Priest Rapids Hydroelectric Project (P-2114)

**SHALLOW WATER HABITAT WATER
QUALITY MONITORING PLAN**

License Article 401(a)(20)

March 2010

Figure 1 Priest Rapids Project Area and established river reaches presented by river mile (RM), mid-Columbia River, WA.

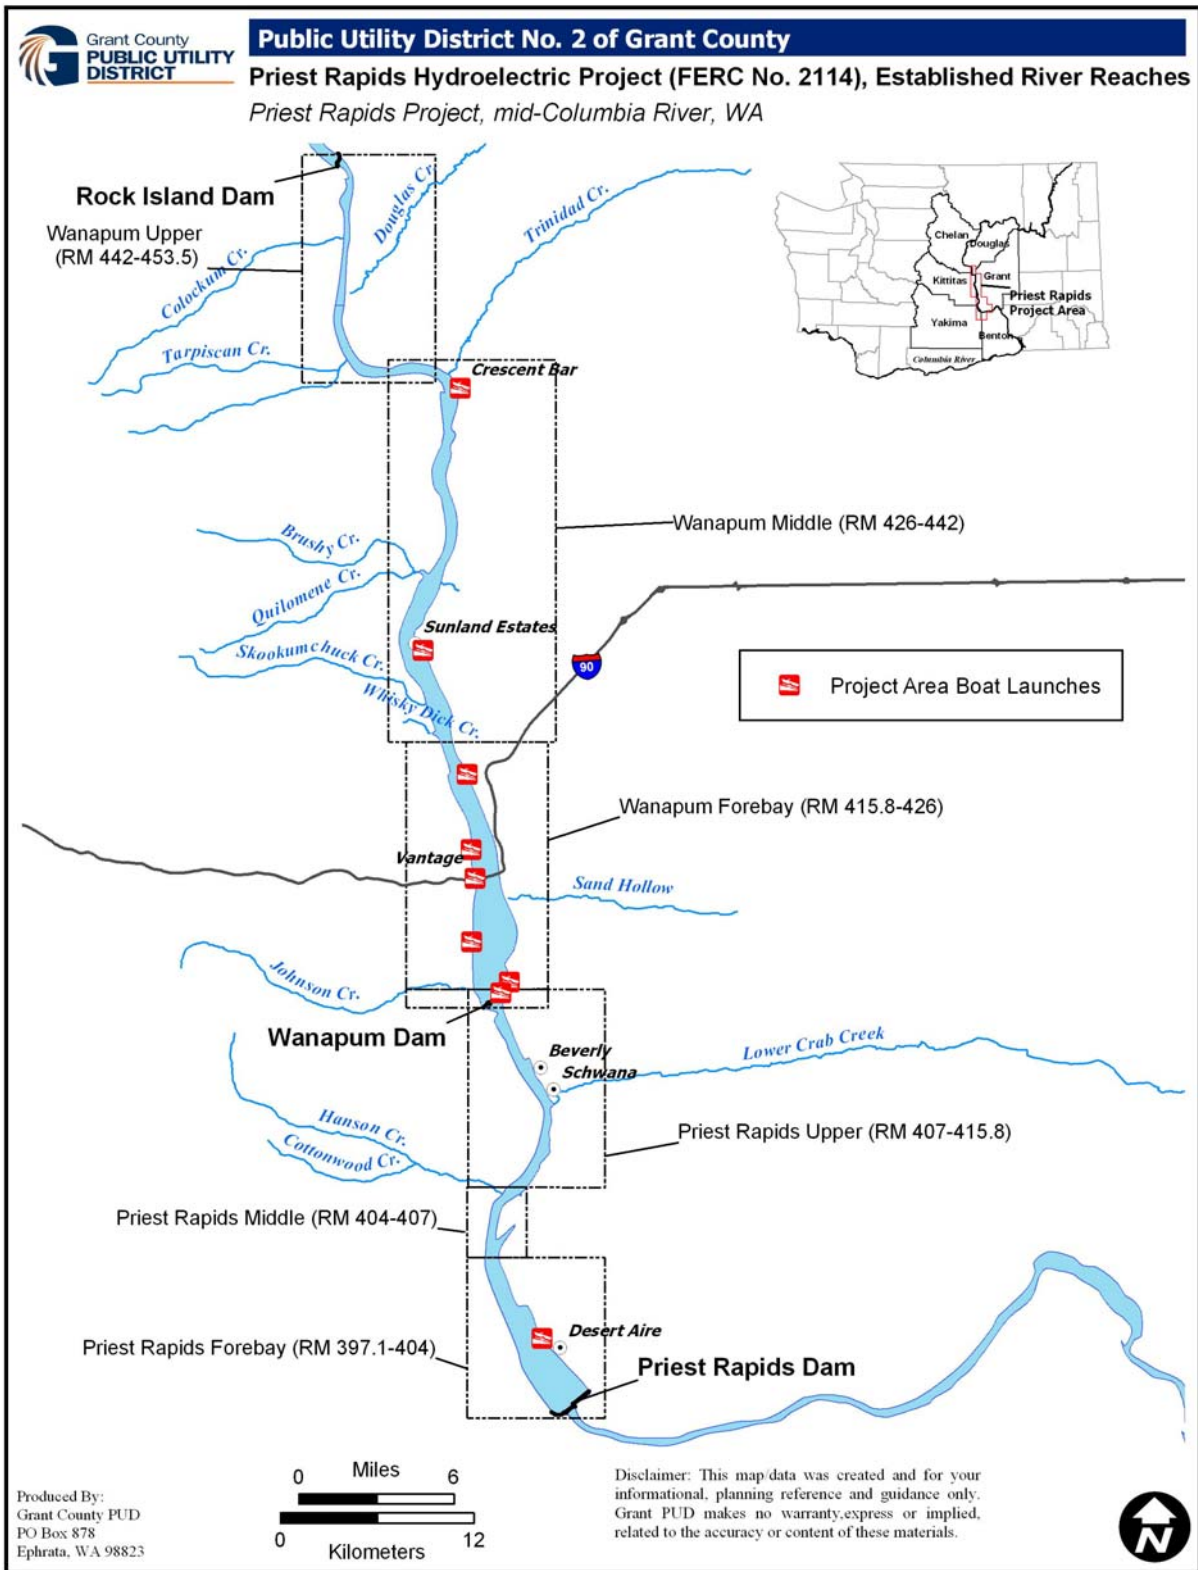
Thanks for including river mileage information in Figure 1 (as per Bryan Nordland's earlier suggestion).

Figure 4 Sample locations used during previous water quality studies (Normandeau et al. (2000) and Juul (2003) within the Priest Rapids Project, mid-Columbia River, WA.

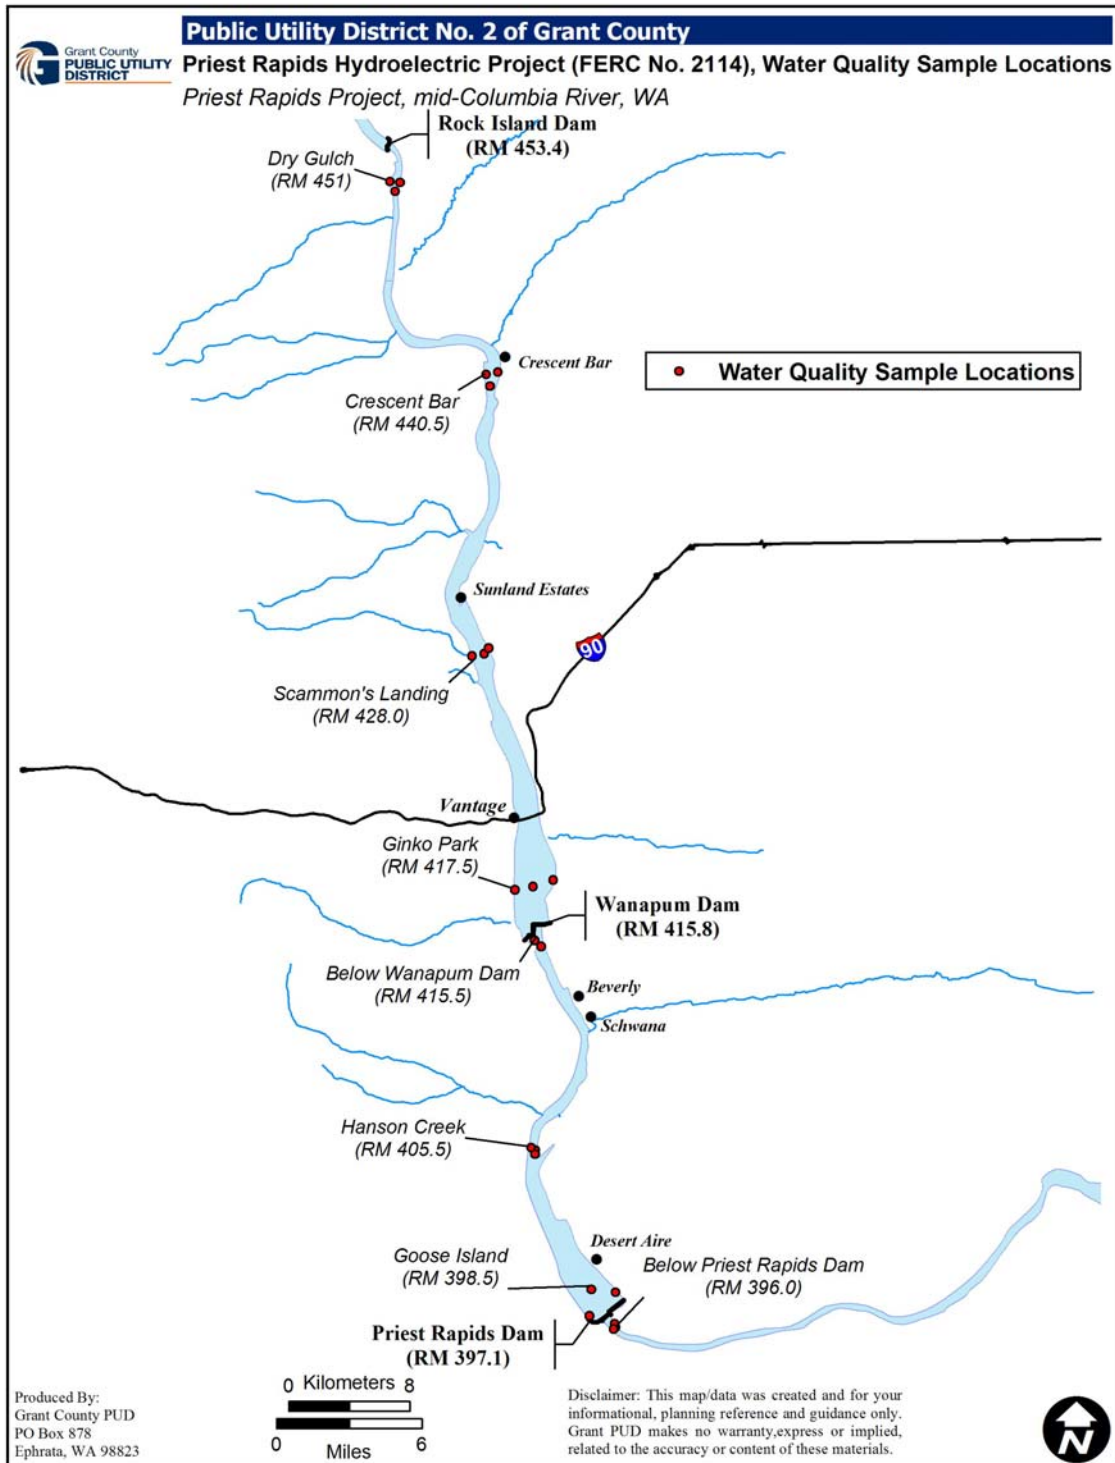
Section 3.1: draft report states that monitoring locations will be at the same locations used during the previous studies (1999 - 2001) and that may be the case but there are some differences between locations given in Figure 4 and Table 1. Granted most sample locations are similar and differences do not exceed 1.5 river miles but there are some differences in name and location.

and that may be the case but there are some differences between locations given in Figure 4 and Table 1. Granted most sample locations are similar and differences do not exceed 1.5 river miles but there are some differences in name and location.	with the exception of the left-bank location at the Hanson Creek transect (see footnote in Table 1). Figure 4 has been updated to accurately reflect the river miles and location titles listed in Table 1.
--	--	--	---	---
